Departure from Sign Design Standards DSDS-697

Application	General Data	
<p>Project Name: Villages of Savannah</p> <p>Location: On the west side of MD 381 (Brandywine Road), approximately 5,000 feet north of the intersection of MD 381 and Floral Park Road.</p> <p>Applicant/Address: Mid-Atlantic Builders, Inc. 11611 Old Georgetown Road, Second Floor Rockville, MD 20852</p> <p>Property Owner: Savannah Investors 5 Inc. Savannah Drive Brandywine, MD 20613</p>	Planning Board Hearing Date:	07/26/18
	Staff Report Date:	07/19/18
	Date Accepted:	06/21/18
	Planning Board Action Limit:	N/A
	Plan Acreage:	518.16
	Zone:	R-R
	Gross Floor Area:	N/A
	Lots:	357
	Parcels:	15
	Planning Area:	85A
	Council District:	09
	Election District:	11
	Municipality:	N/A
200-Scale Base Map:	216SE05

TECHNICAL STAFF REPORT

REQUEST: **Departure from height and area requirements for two freestanding gateway signs.**

LANDSCAPE PLAN WITH APPROXIMATE SIGN LOCATION HIGHLIGHTED

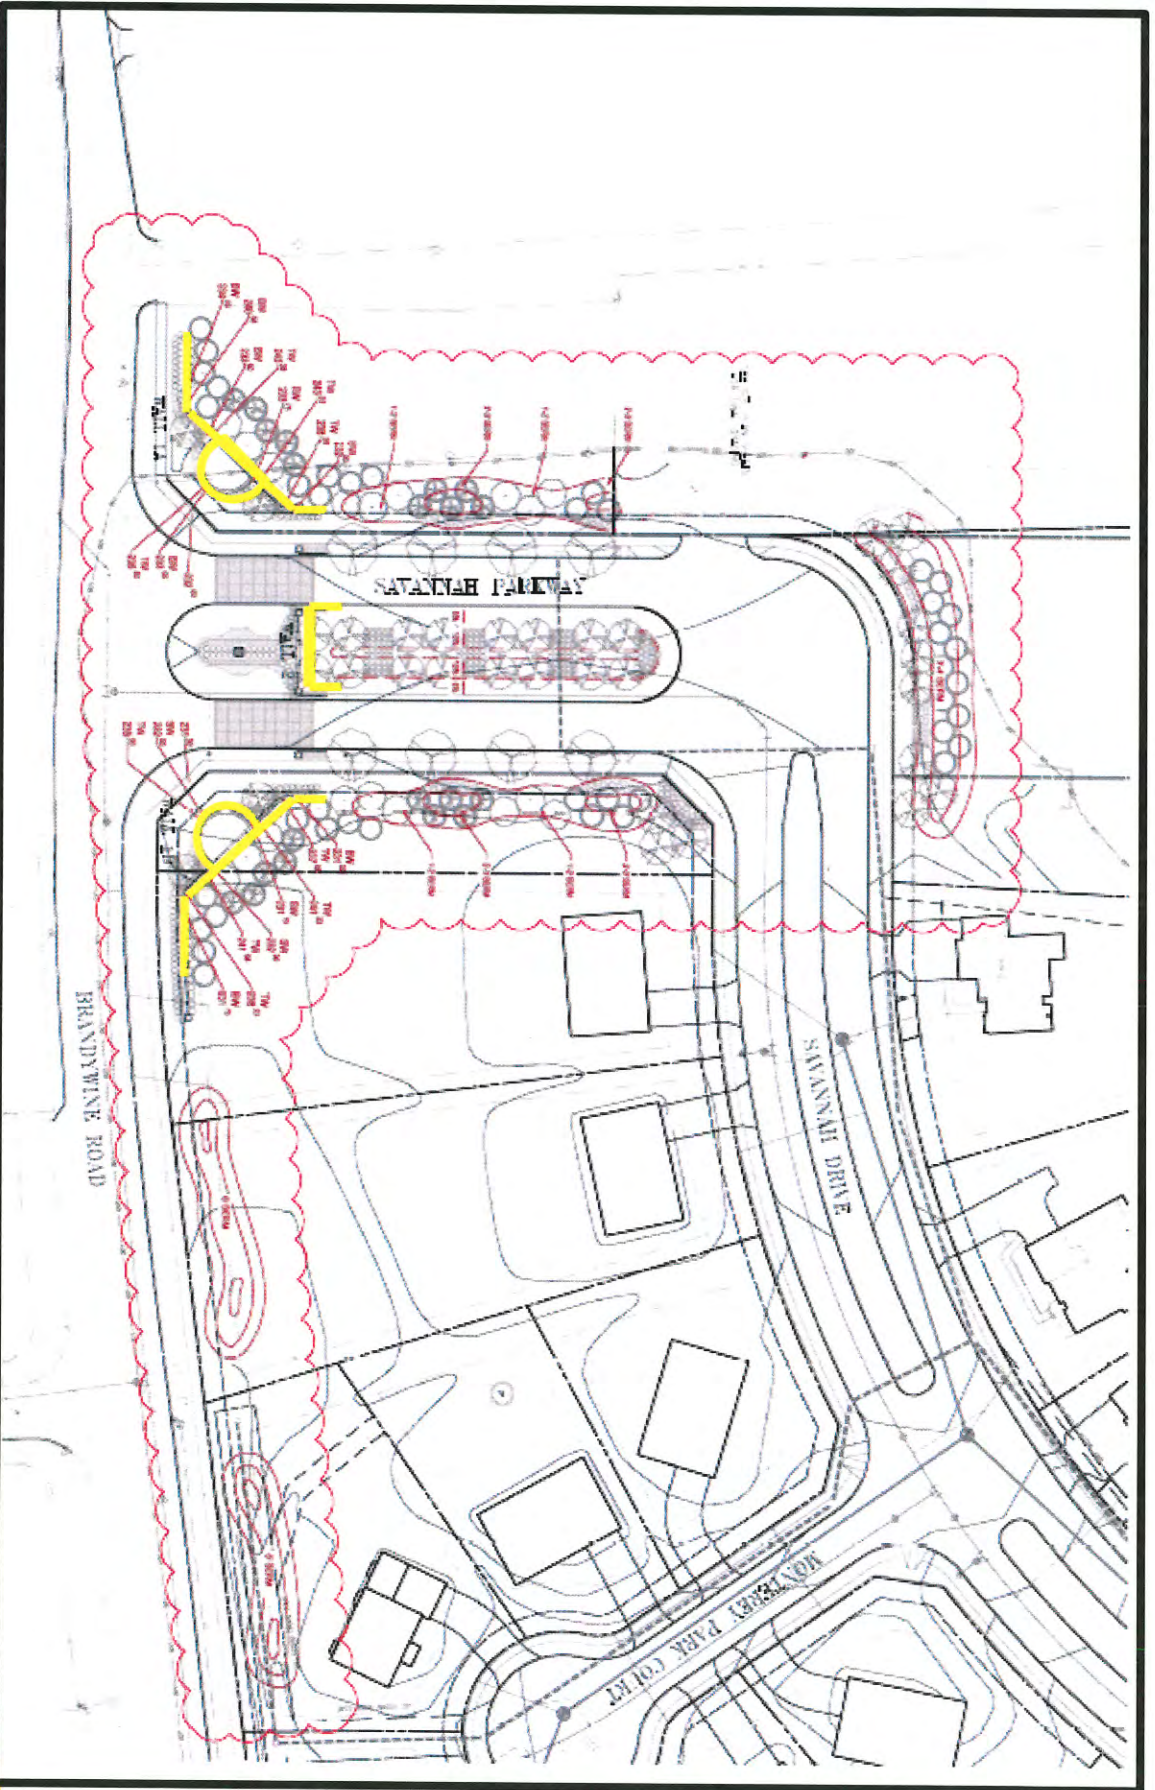
Prior to certification of the site plan, staff recommends that a parcel be created that is of sufficient size to contain the proposed entrance feature and all required landscaping.

- e. Pursuant to Subtitle 24 of the Prince George's County Code, the applicant shall create a parcel of sufficient size to contain the gateway signage entrance feature and all required landscaping, to be conveyed to the homeowners association. The parcel shall be reflected on the site plan prior to certification.
2. Prior to issuance of the sign permit:
- a. The detailed site plan shall be amended to reflect the signage associated with this application.
 - b. A landscape and entry feature easement, or covenant, for the gateway signage/entrance feature on Lot 1, to be maintained by the Villages of Savannah Homeowners Association, shall be recorded.

ENTRANCE FEATURE DETAILS

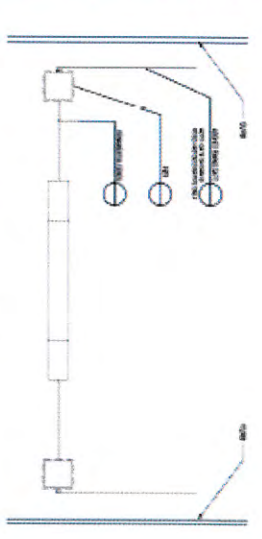
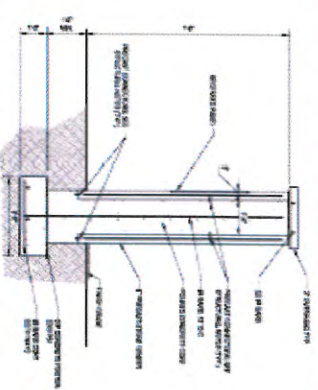
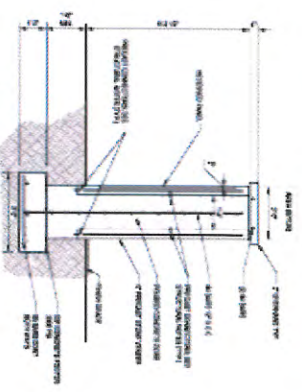
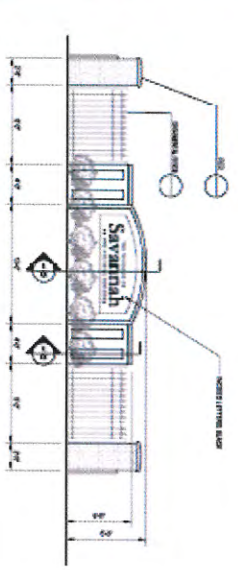
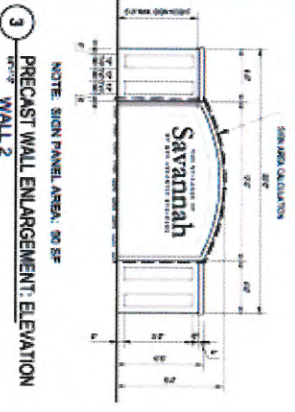
Staff notes that the proposed signs are labeled as Wall 1A, Wall 1B, and Wall 2. These should be relabeled as Sign 1A, 1B, and 2 for clarification.

**Wall 2 (Median sign) is not part of this DSDS application because the sign is located in the public right-of-way. A condition is recommended to relabel the median sign details on the chart as Sign 2 and clarify that all sign details for Sign 2 on the site plans are not part of this DSDS approval, and are provided for information purposes only.

1. Prior to certification of the departure site plan, the plans shall be revised to:
 - a. Remove the repeated data tables for the departure from sign design standards from all pages of the site plan, except page 2B of 36.
 - b. Relabel from Wall 1A, Wall 1B, and Wall 2 to Sign 1A, Sign 1B, and Sign 2 for clarification.
 - c. Add a general note on the site plan stating the proposal for this departure from sign design standards application.
 - d. Relabel the median sign details and chart to indicate that the median sign is not part of this application and is provided for informational purposes only.
